April 27, 2016

Project No: 151-12617-00

**RE: RM OF RITCHOT – ST. ADOLPHE LAGOON
NOTICE OF ALTERATION – LICENCE No: 2776 (REVISED)**

TOTAL LAGOON STORAGE VOLUME = 141,325 cu.m

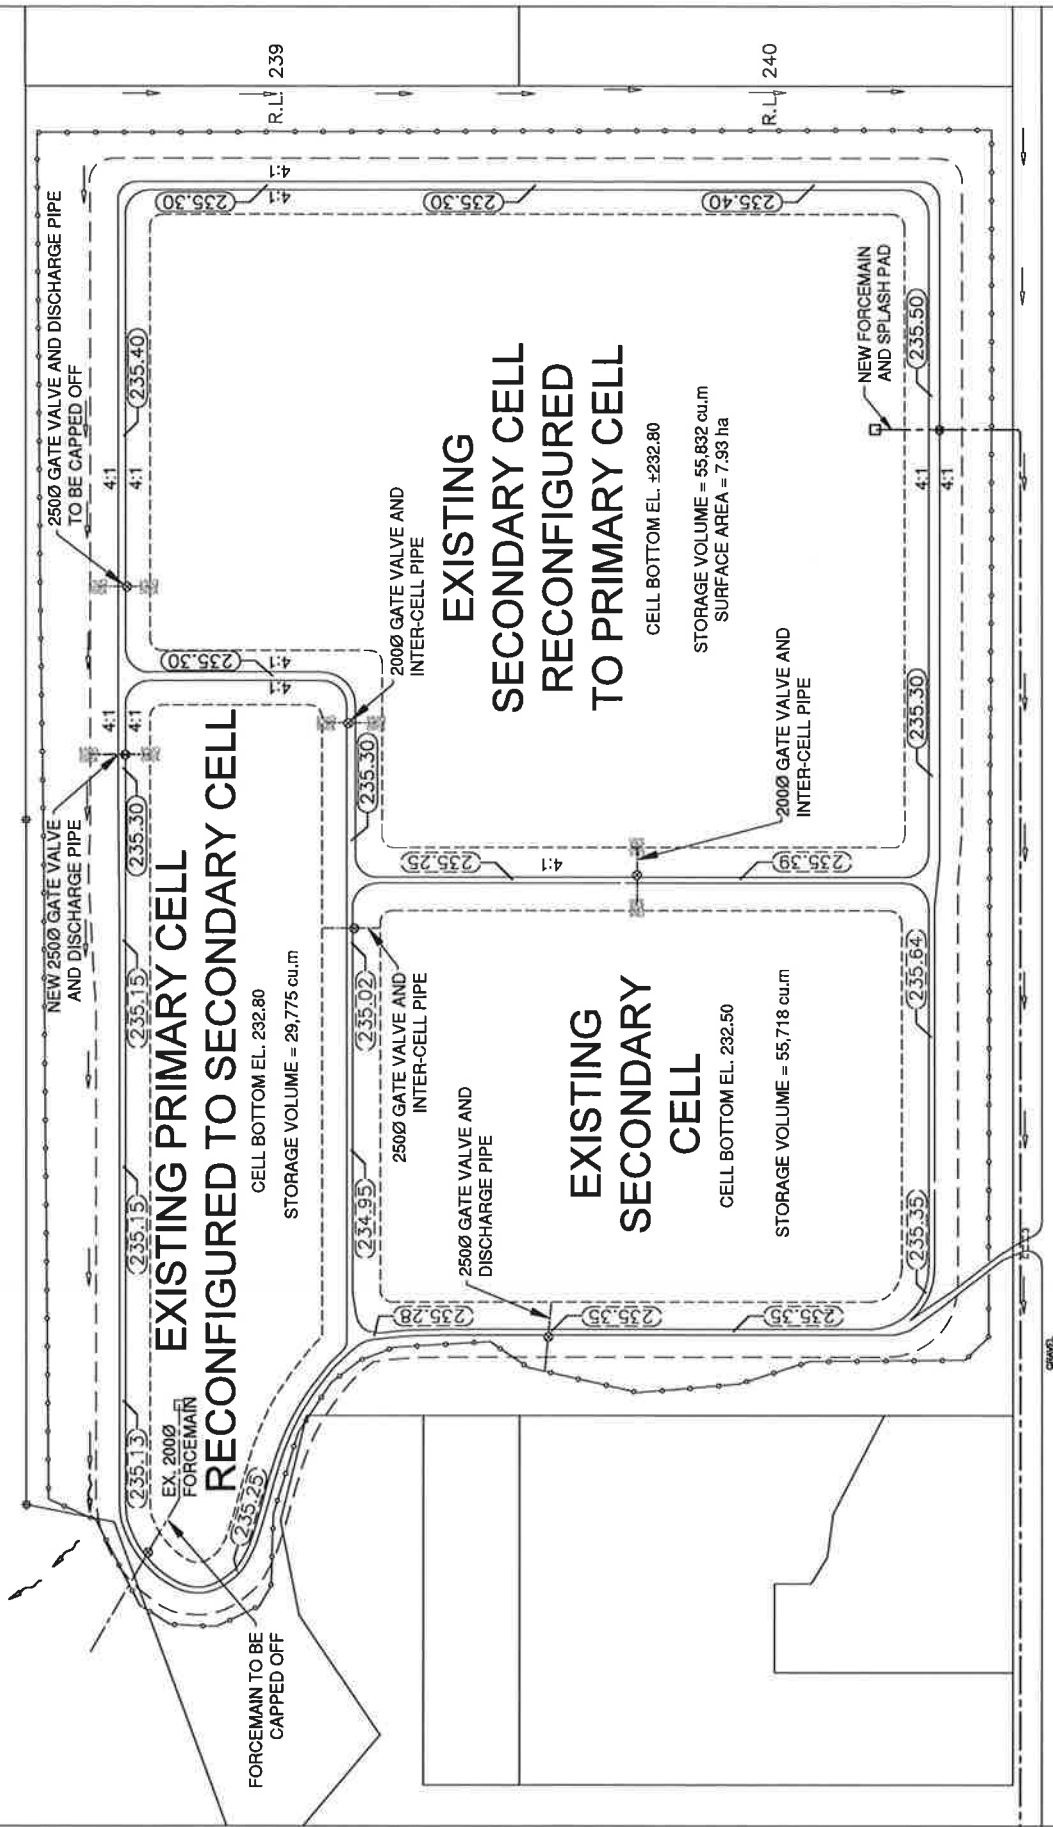
A simple solution for the short term (Phase 1) is to convert the newest (east) secondary cell to the primary cell and convert the primary cell to a secondary cell. The new forcemain from the new subdivision lift station will be installed along the south municipal road before entering the new primary (east secondary). The old forcemain from the existing lift station is to be twinned from the existing lift station to a point across the St. Adolphe Coulee from the lagoon, joined with a "T" and then a new line will be directionally drilled into the new primary (east secondary) cell. The new secondary (old primary) will then require a discharge pipe and valve which will be located on the north side and drain along the north side of the lagoon facility to the St. Adolphe Coulee, utilizing the existing discharge route. The new primary will have its' discharge pipe on the north side capped off. This is further detailed in the attached drawing.

With the re-configuring of the cells, the east secondary/new primary will provide a surface area of approximately 7.93 hectares, good for approximately 5,770 people and the resulting storage will be approximately 141,325 cubic metres. The present flows are averaging 290,000 L/d over the storage period and divided by the present
